Response to NYSDEC Supplemental Remedial Design Work Plan Addendum (June 2009) and Supplemental Final Engineering Report (March 2009) Comment Letter
Former Roehlen Engraving
NYSDEC Site #828077
Henrietta, New York

Date:
July 27, 2009

Subject:
Supplemental Remedial Design Work Plan Addendum (Revised July 2009)
Former Roehlen Engraving
NYSDEC Site #828077
Henrietta, New York

STANDEX INTERNATIONAL CORPORATION FORMER ROEHLEN ENGRAVING SITE HENRIETTA, NEW YORK	
PROCESS FLOW DIAGRAM INJECTION INFRASTRUCTURE	
	FIGURE 3

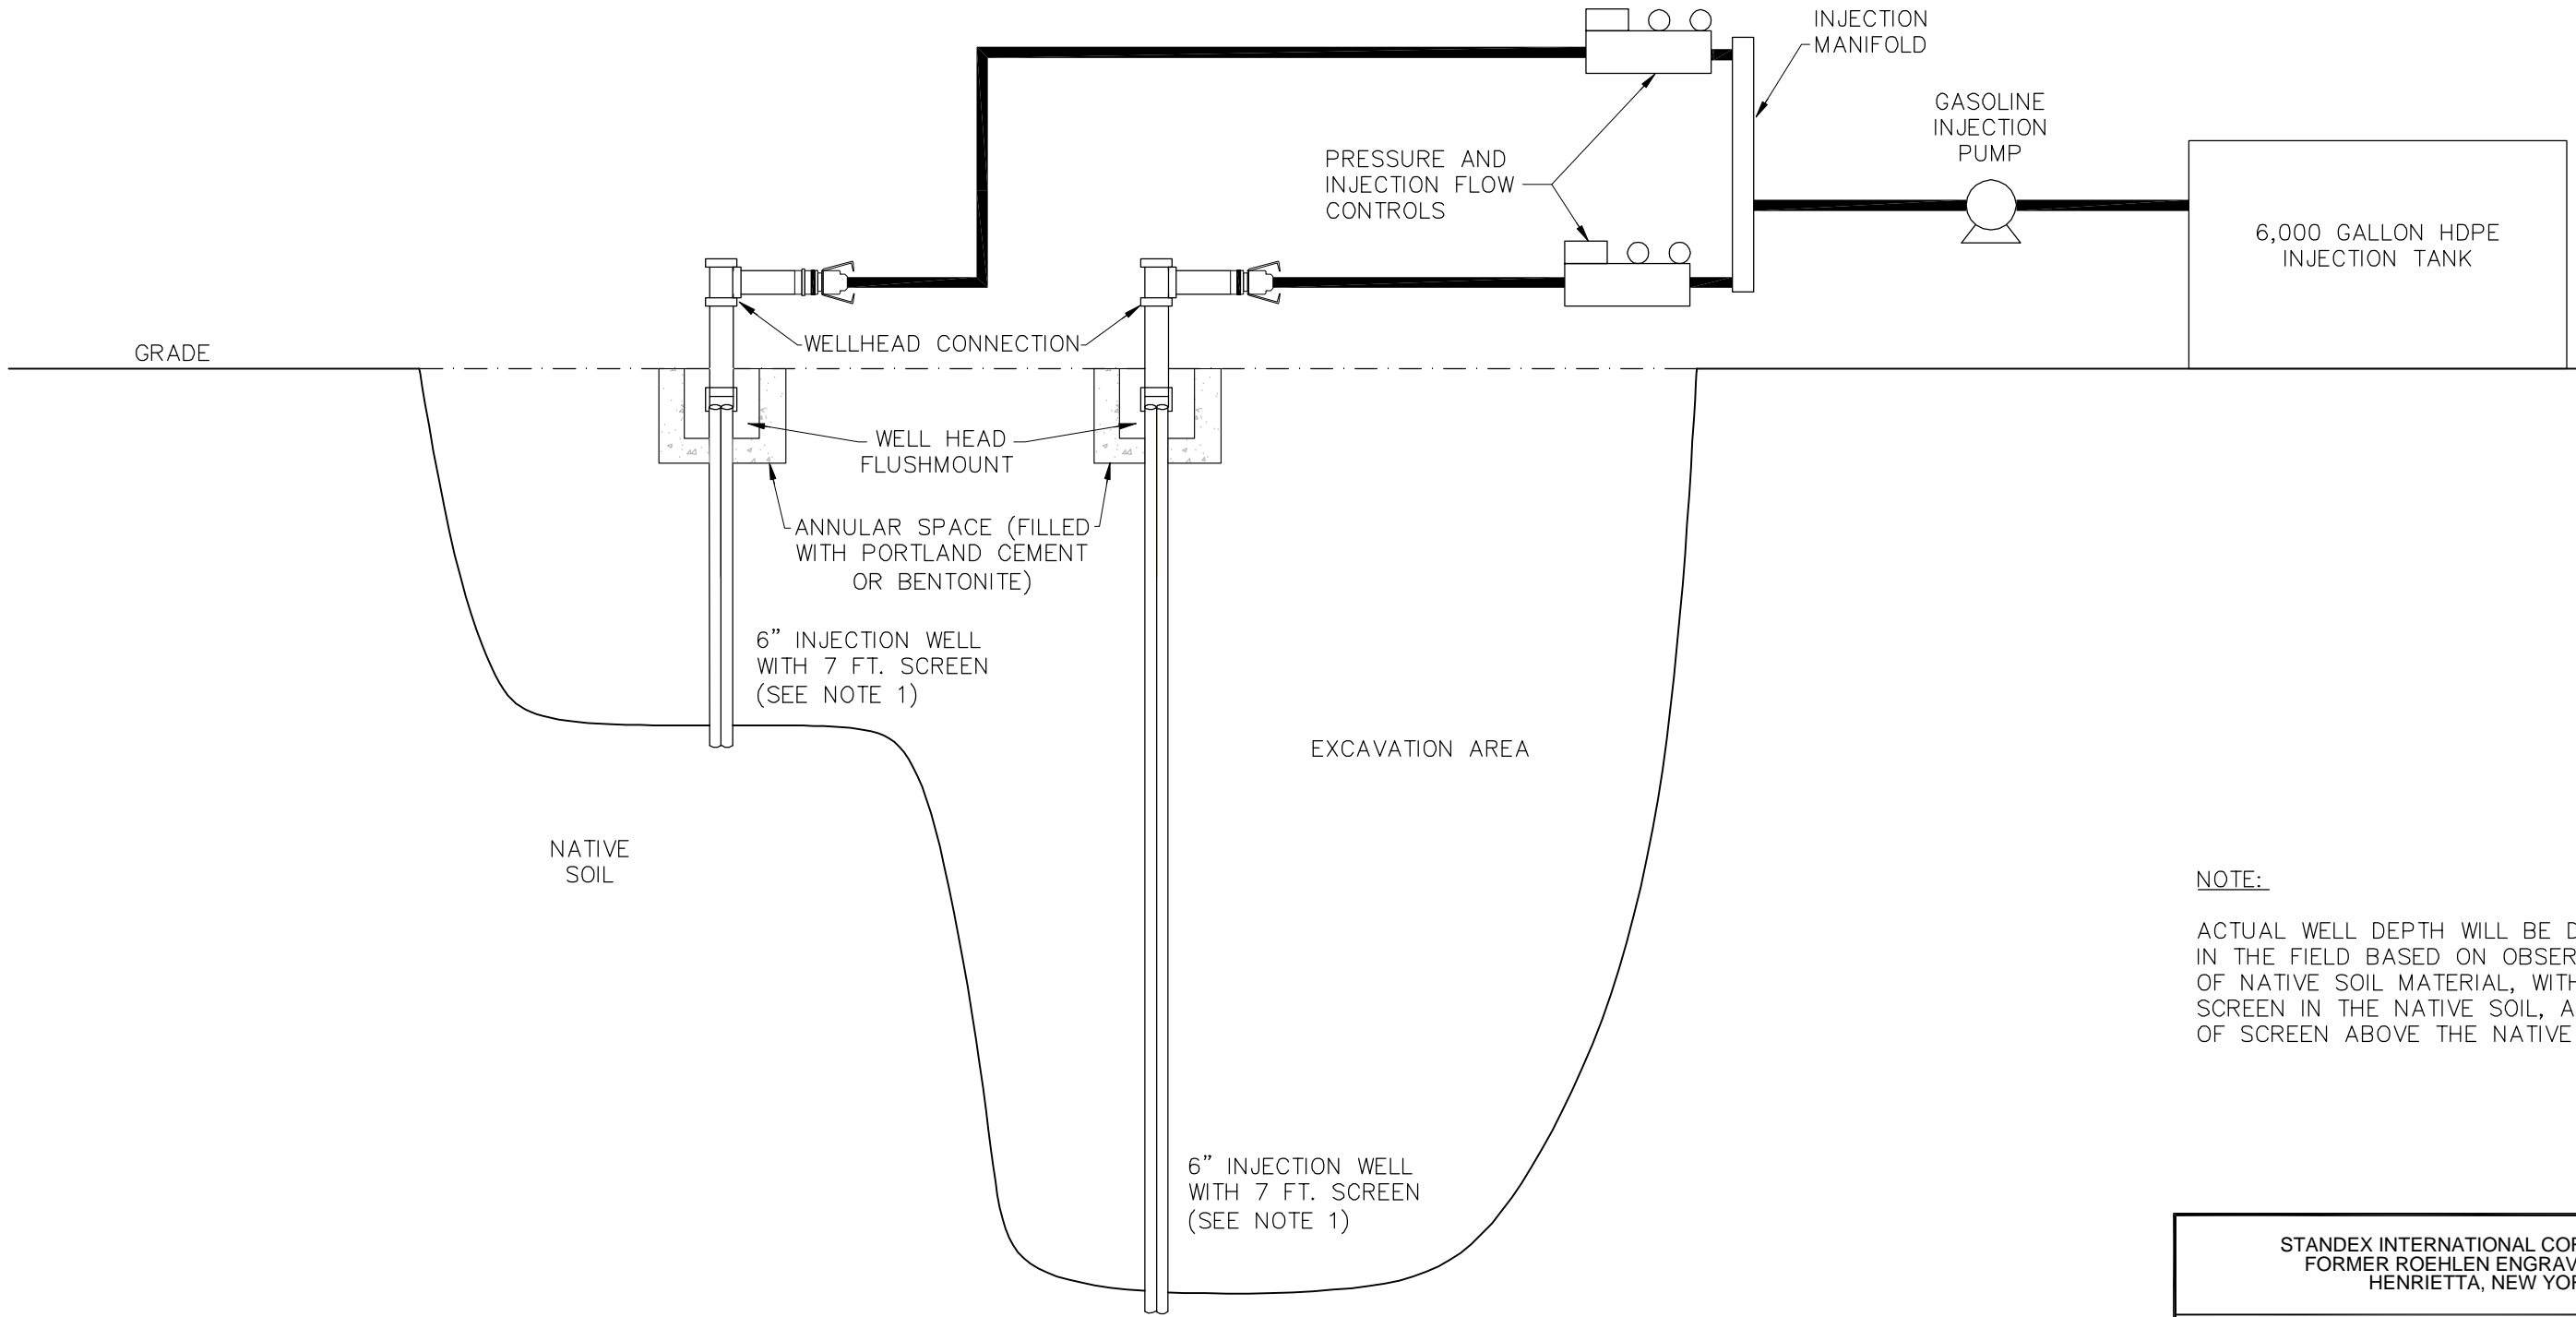
Furthermore, injection outside the excavation foot print should be considered. Either installation of an additional injection well outside of the excavation area or modification of the proposed shallow injection well to deeper injection well with a screened interval within the native soil and backfill should be evaluated.

In a recent telephone conversation with the NYSDEC, ARCADIS agreed to have a portion of the screened section of the two proposed injection wells to be advanced into the native soil below the imported backfill. The design of the two proposed injection wells have been revised such that the screened section of each well will be advanced approximately 2 feet into the native soil. This will be confirmed by obtaining soil samples and observing the recovered soil cores. Figure 3 of the enclosed SRD Work Plan Addendum (Revised July 2009) shows the injection well revisions.

NOTE:
ACTUAL WELL DEPTH WILL BE DETERMINED IN THE FIELD BASED ON OBSERVED DEPTH OF NATIVE SOIL MATERIAL, WITH 2 FEET OF SCREEN IN THE NATIVE SOIL, AND 5 FEET OF SCREEN ABOVE THE NATIVE SOIL.
